# Technical Service Information

## EAGLE 4HP-18 HARSH 4-3 COAST DOWNSHIFT

Figure 1

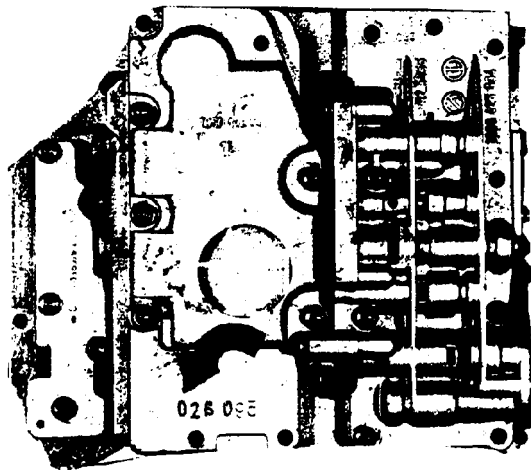
**CORRECTION:** The Forward (A) clutch accumulator orifice has been reduced in later valve bodies. To determine the update level of the valve body, refer to the first three numbers stamped on the filter cover. **See Figure 1.** If the valve body is the early style with either the 026 or 032 filter cover, check the valve body orifice (A) and reduce it as necessary to .047 in. **See Figure 2.**

See arrow on cover to locate identification numbers.  
Production numbers beginning with 026 or 132 are early model.  
Production numbers beginning with 052, 068, or higher are late model.

Figure 3

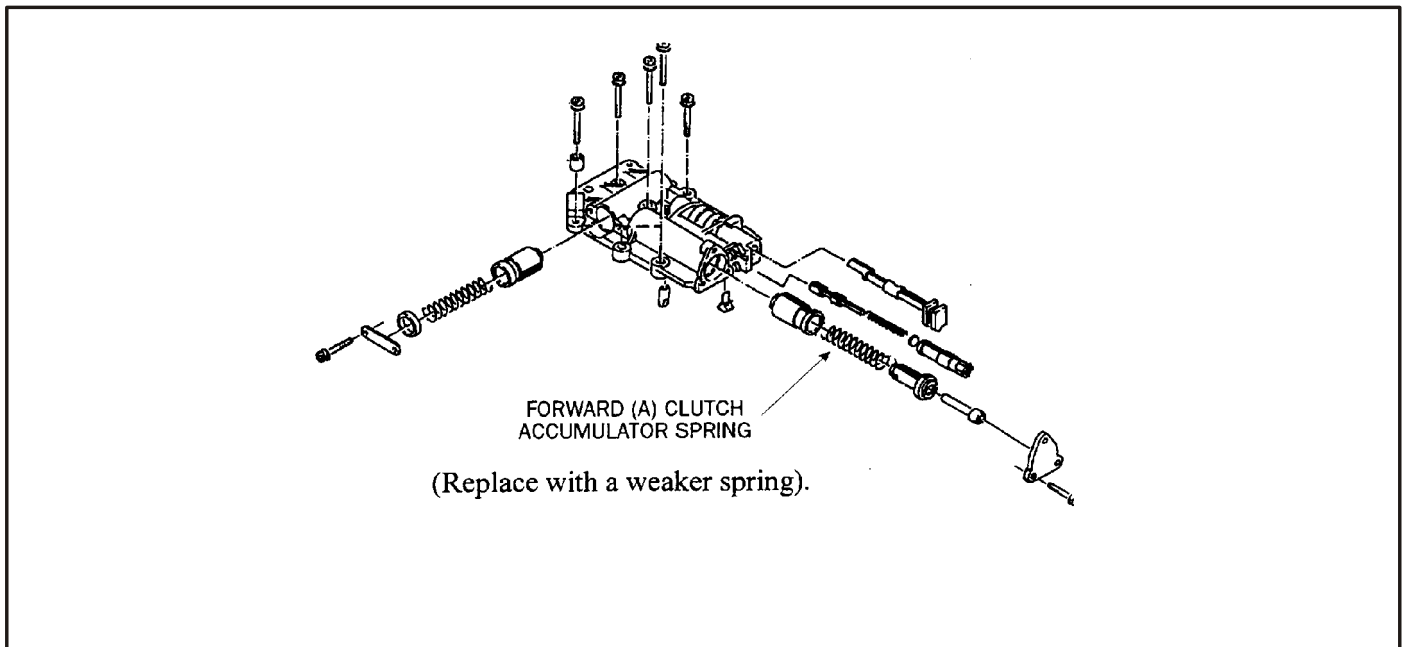
If this does not correct the problem, or if the valve body filter cover is 052, 068, or higher, then it will be necessary to install a lighter spring into the Forward (A) clutch accumulator. The pressure regulator spring from a 350 valve body will fit nicely and soften the clutch as it reapplies during a coast downshift. **See Figure 3** for the location of the Forward (A) clutch accumulator.
